Part 20.25A Downtown

20.25A.010 General.

Figure 20.25A.090.A.1.

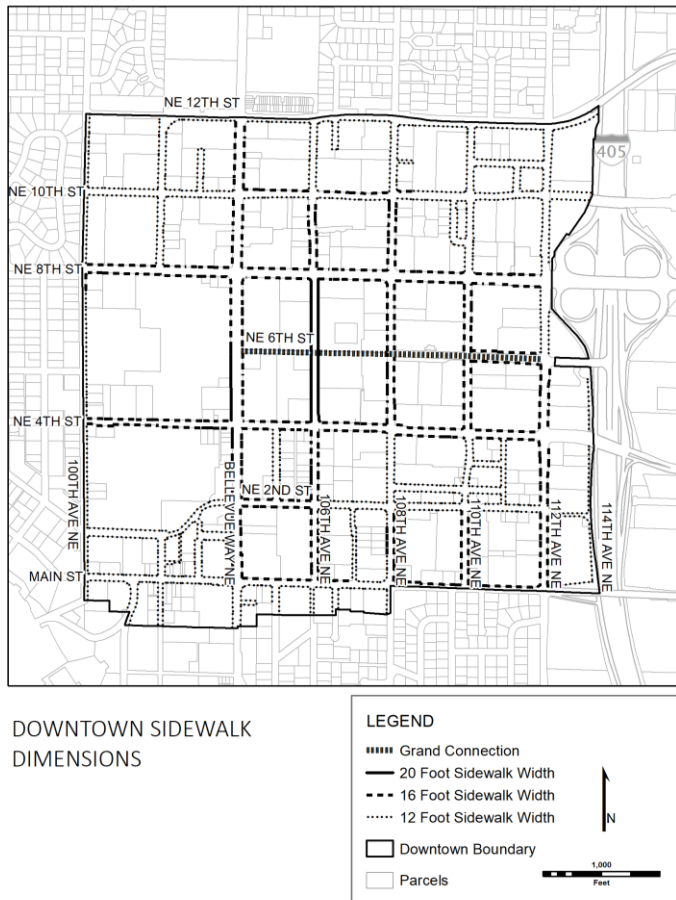
Commented [A11]: Legend updated for consistency.

Figure 20.25A.170.B.

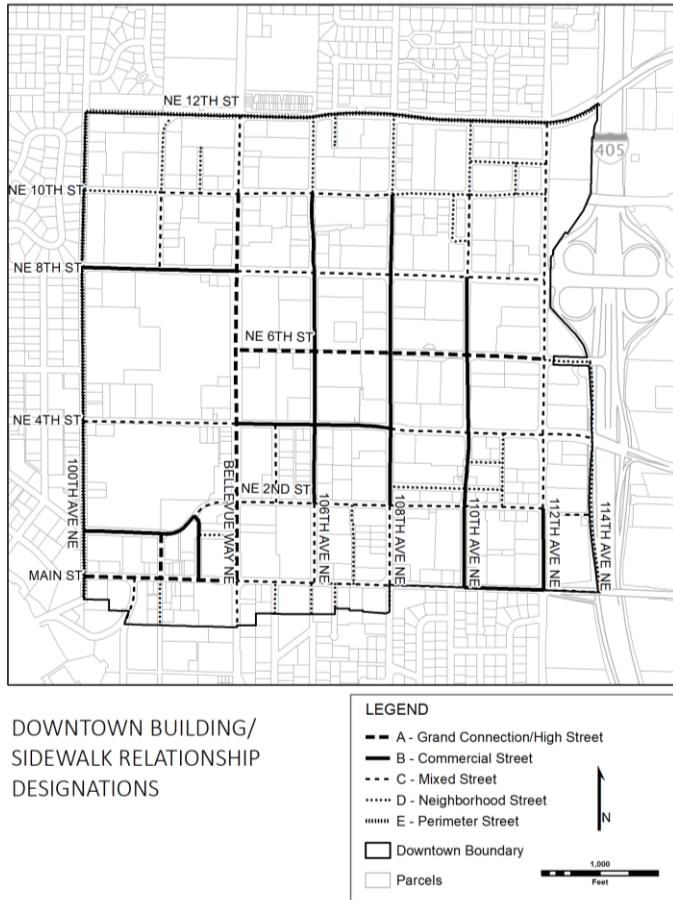
Commented [A14]: Legend updated and 102nd Avenue NE, between NE 1st Street and Main changed to "A" ROW to align with the new Grand Connection section.
